# PITTS AVIATION ENTERPRISES, Inc.

## SERVICE BULLETIN NO. 8

**APPLICABILITY:** This service bulletin applies to Pitts Model S-1S airplanes from Serial No. 1-0001 through 1-0025. Serial No. 1-0026 and up will be modified at the factory, as will replacement wings S/N K013 & up.

**PURPOSE:** To inspect the upper wing leading edge for failed leading edge ribs and if failed leading edge ribs are found, to repair them acceptably. Compliance with this service bulletin is mandatory.

PITTS AVIATION ENTERPRISES, INC.SERVICE BULLETIN NO. 8NOTES: (Ref. sketch page 2 of 3)

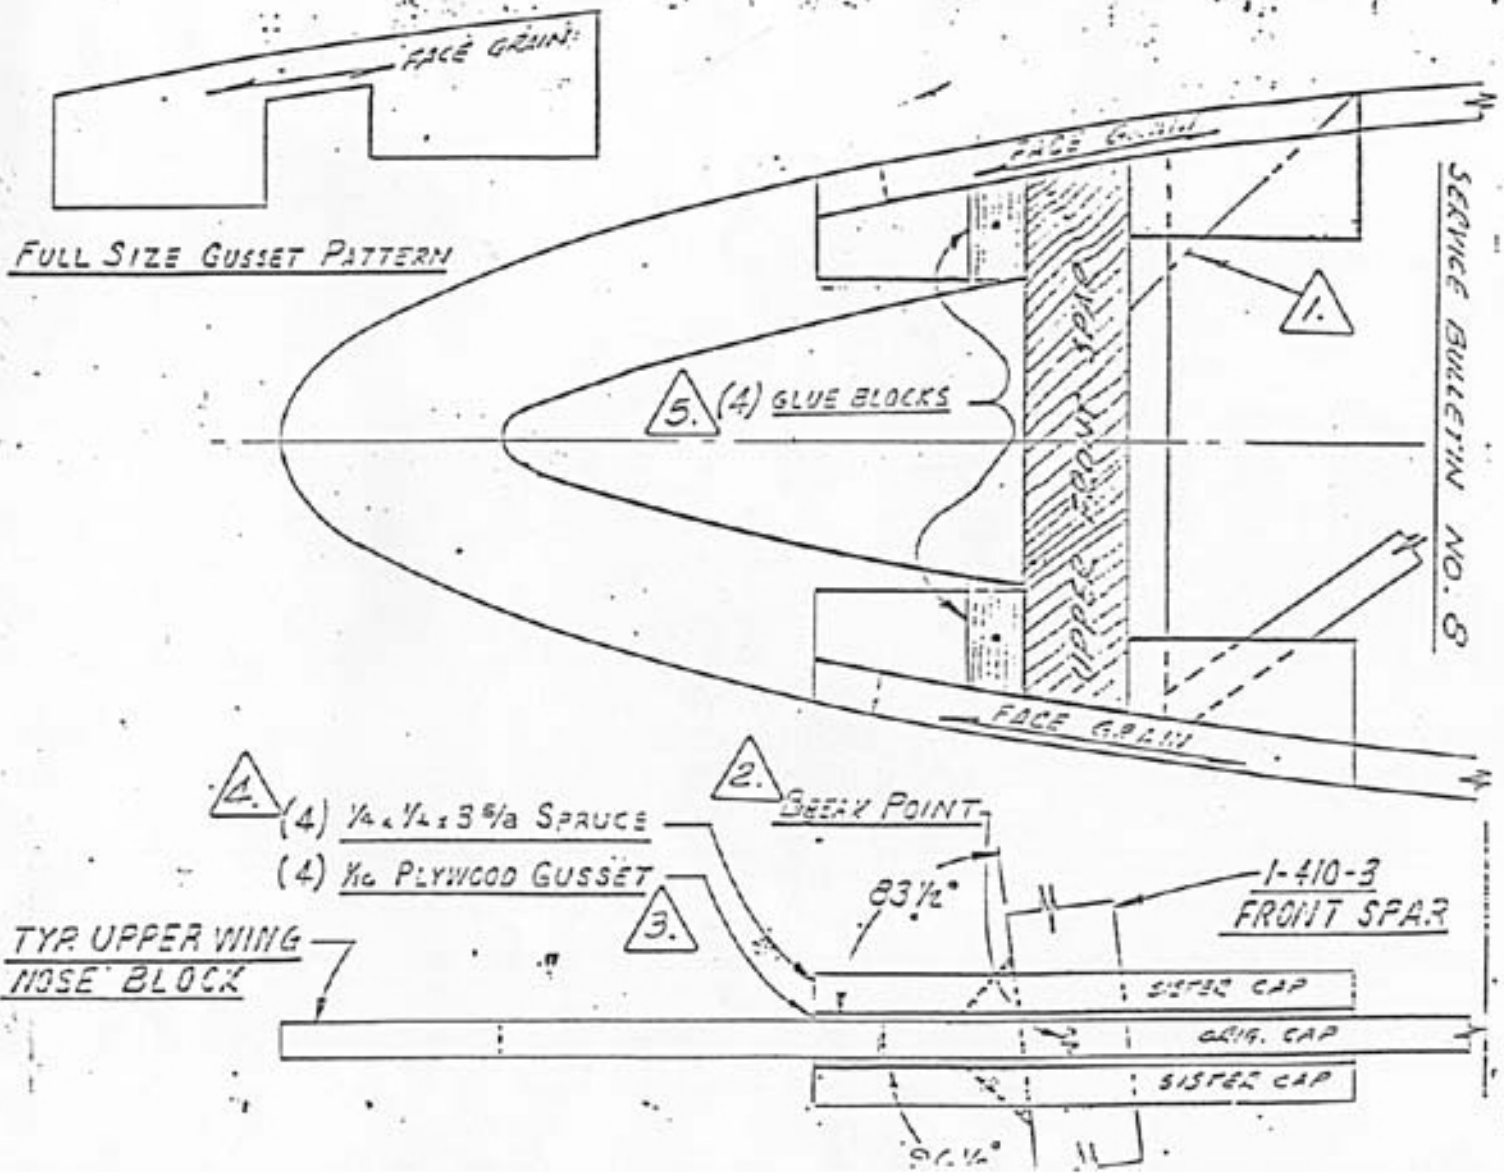
3. If damage to leading edge ribs is noted, then the damage must be repaired as shown on page 2 & 3 of this bulletin.

1. Remove existing plywood gussets, eight places each rib. (See note 6.)
2. Do not "clean up" fracture - push fibers back together and glue. Glue to be Weldwood Plastic Resin Glue. Manufacturer's instructions for use must be followed. All varnish must be removed from surfaces to be glued.

3. Mahogany/poplar/mahogany plywood per MIL-P-6070, or MIL-P-18066.
4. Spruce to be aircraft quality per MIL-S-6073.
5. Four per rib. Note bevel angles shown in lower view. Each glue block to be secured while glue dries by one 18 gage cement-coated aircraft nail, 3/4" long. Make from spruce per note 4 above. Glue faces, on rib and spar, to be 3/8" minimum width.

6. At root ribs, make repair on outboard side of ribs only. On compression ribs, 1/16" plywood filler is required to fill gap across spar between original gussets. Do not remove gussets on compression ribs - add four large repair gussets, (Shown full size, sheet 2 of 3), on top of existing gussets. Else as shown.
